**JOINT REGIONAL PLANNING PANEL**  
**(Hunter Central Coast Region)**

<b>JRPP No</b>	2016HCC038
<b>DA Number</b>	DA/624/2016
<b>Local Government Area</b>	Central Coast Council
<b>Proposed Development</b>	Masterplan development application for mixed use development comprising 81 residential units (in two tower elements), retail space and car parking
<b>Street Address</b>	10 Denning Street & 1-5 Short Street, The Entrance Lots D, E, F & G DP 348224, Lot 1 DP 102735, Lot 11 DP 17376, Lots 1 & 2 DP 1219145
<b>Applicant/Owner</b>	Central Coast Council
<b>Number of Submissions</b>	Two objectors
<b>Regional Development Criteria</b>	Lodged prior to 1 March 2018 Clause 3 –Development with a CIV exceeding \$5 million and Council related
<b>List of All Relevant s79C(1)(a) Matters</b>	<ul style="list-style-type: none"> <li>• State Environmental Planning Policy No. 65 – Design Quality of Residential Flat Buildings</li> <li>• State Environmental Planning Policy No. 71 – Coastal Protection</li> <li>• Draft State Environmental Planning Policy – Coastal Protection</li> <li>• State Environmental Planning Policy (State and Regional Development) 2011</li> <li>• State Environmental Planning Policy (Bu

Figure 12 – Road closure lots subject to Clause 4.6 request

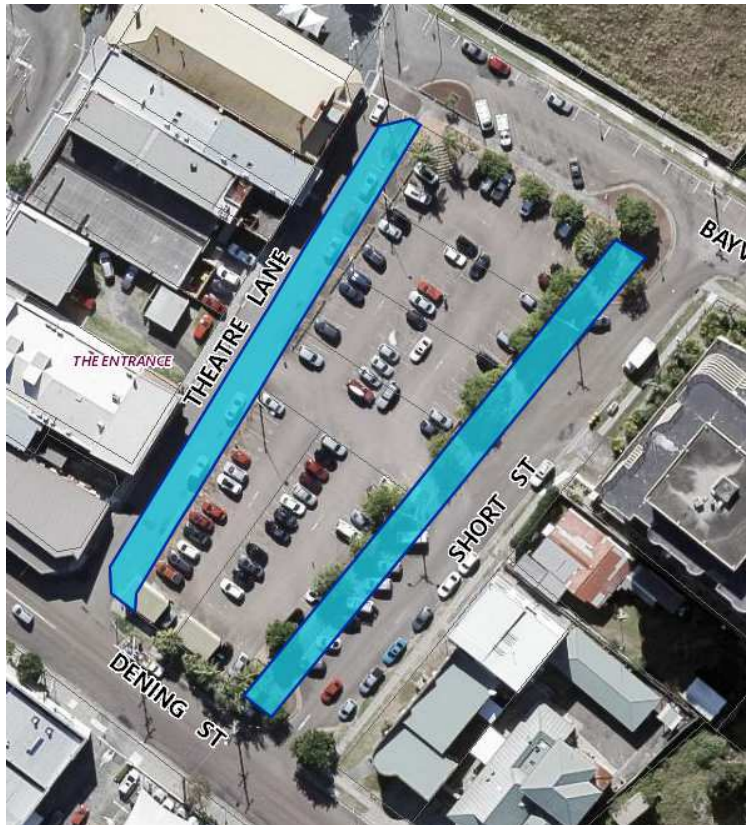
A Clause 4.6 exception to the maximum permitted building height (WLEP Clause 4.3) applying to the site is sought under the development application. The development standard under Clause 4.3 of WLEP 2013 limits the maximum building height on the site to 50m for the identified key site and 23m for the closed road portions of the development site. The proposal seeks a maximum height of 46.15m. The exceedance of the height occurs within the closed road portions of the site as identified by the extract of Figure 2.2 from the Clause 4.6 Variation Request submitted by the applicant.

Figure 13 – Elevations depicting areas subject to Clause 4.6 request

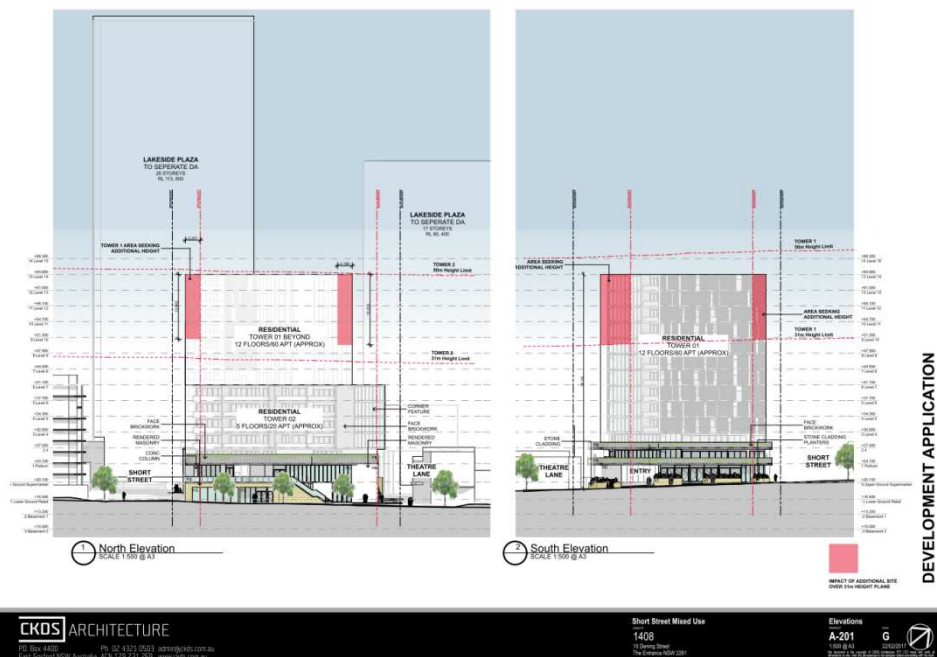
The variation sought is 23.15m. The elevations below seek to illustrate the extent of the variation. It is noted that the 31m height limit is indicated not the applicable 23m as identified on the height of building map.

- The extent of the variation is incorrectly quantified as 6.9% of the built volume. The height control is not a massing control and comparison of the mass of the building which complies to that which does not is not a relevant assessment. The extent of the variation is in 100.6%. It is noted that the actual variation as a percentage of the building volume is greater than 6.9% when accounting for the variation in height from the 23m height plane.

- The consideration of the objectives of Clause 4.3 states incorrectly that: "*Shadow diagrams have been prepared to demonstrate that a building compliant with the 31m height limit on Lots 1 and 2 in DP 1219145 would produce the same overshadowing for adjacent dwellings as the 46.15m building proposed. Consequently, the objective would be no better achieved by smaller sections of the building on those two allotments than it is by the proposal.*" The correct analysis would be of a 23m building height.

For these reasons and consideration of the principles developed by the Land and Environment Court, the variation of Clause 4.3 is not supported. It is noted that concurrence of the Secretary of the Department of Planning and Environment would be required to be assumed to support the Clause 4.6 variation of Clause 4.3 Maximum Height of Buildings.
